## URBAN DESIGN CONSULTATION RESPONSE

| Application Reference | PL/2026/0679                                                                                                                |
| Address               | Land Off Heywood Old Road, Middleton, OL10 2HZ                                                                              |
| Proposal              | Construction of an SEN school, with associated access, parking, landscaping, drainage, land regrading and associated works. |

### Cladding Areas

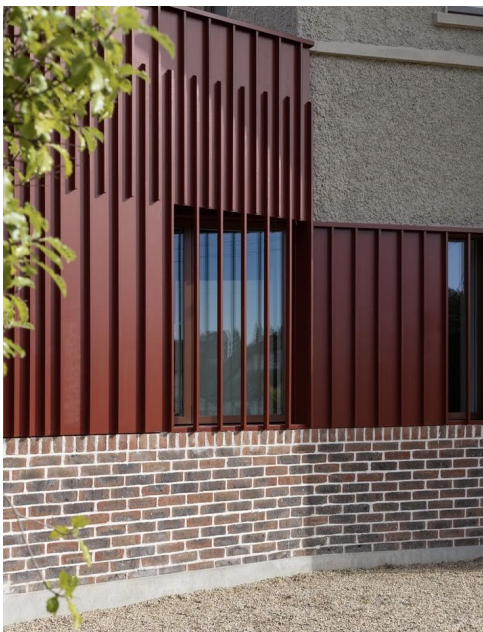
Due to the lack of detail and design precedents illustrating the intent for the cladding areas, I am unconvinced that this element adds value rather than making the building appear unnecessarily complex, mismatched, and somewhat haphazard. As shown, the cladding does not convey a high-quality design. Furthermore, I am concerned that 'timber effect cladding' is simply a low quality alternative to actual timber - where 'stick-on' cladding has been used elsewhere in the borough, it has rarely aged well and can quickly appear dated.

The rationale made by the applicant that this material is 'in keeping with the 'rural' character of the site and Green Belt backdrop to the north...' is rather weak and unconvincing.

If brick is intended to be the primary material, these 'timber effect' areas could instead be expressed through a more considered and stylised application of brick detailing, resulting in a stronger and more cohesive design.

Similarly, I am not convinced by the use of Rockpanel in these areas for the same reasons. As a flat applied product, it risks appearing superficial and could give the building a rather tacky appearance. The intended effect may be achieved more successfully by recessing these areas slightly and using a material such as glazed brick if the colour palette is a fundamental part of the design concept. Used selectively, this would not be prohibitively expensive and would deliver a far more durable and high-quality outcome. As a complementary material to the primary brickwork, it would create a much more coherent and effective composition.

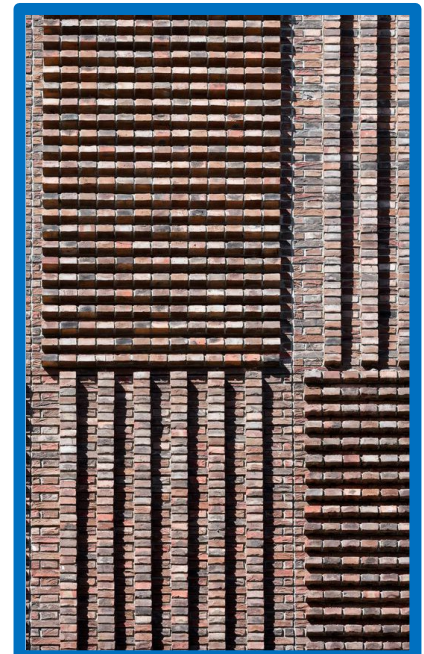
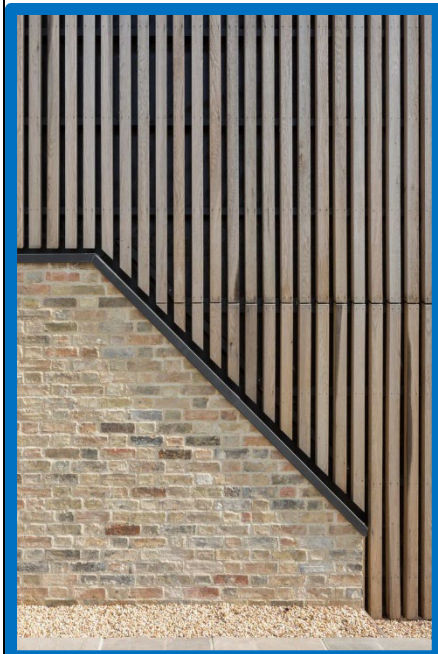
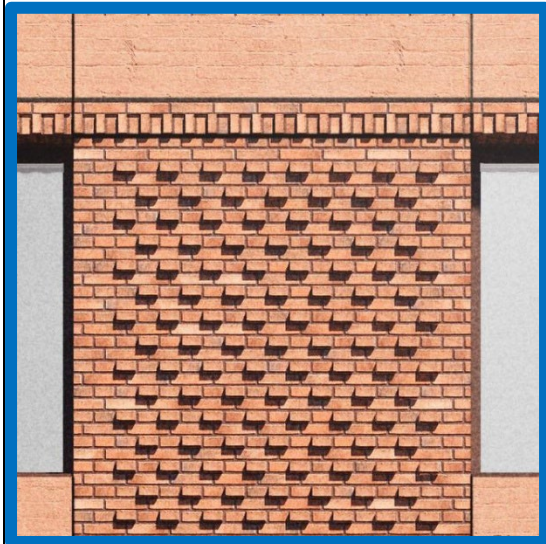
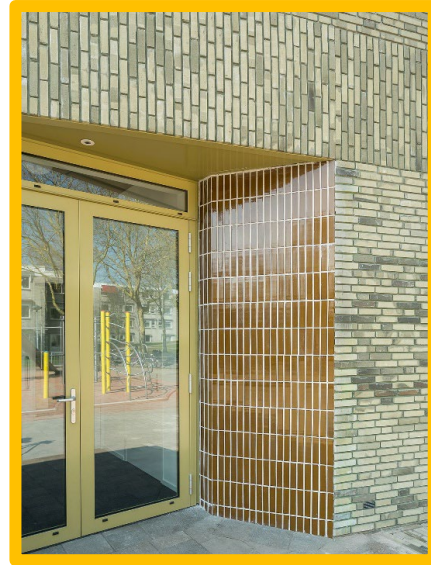
They are noticeably distracting and overbearing, exerting a negative influence on the elevational design. The primary entrance canopy is excessive in its projection, compromising the building's form and legibility. There appears to be no clear justification for it extending as far as the footpath, raising

Similarly, canopies appear to have been added to every classroom and HomeZone entrances. Their proliferation is excessive and their design lacks integration with the wider architectural composition. This approach should be rationalised and, if canopies are considered essential, an alternative design strategy should be explored, albeit one that may have cost implications.

1. A stronger design response would be to recess entrance areas, introducing depth and visual interest to the elevations. This would likely require wider corridors and deeper recesses, potentially necessitating additional structural support to the oversailing roof.
2. Alternatively, and particularly for the rear classrooms, the roof could be cantilevered to provide the required shelter. Given the importance of the roof design, and the strong preference for parapet roofs to avoid the bulky and visually dominant roof forms highlighted at pre-application stage, this approach would provide greater architectural interest but again have added cost implications.
3. In selective areas, have cantilevered slim profile canopies but the extent to which they overhang would have to be reduced for this to be possible
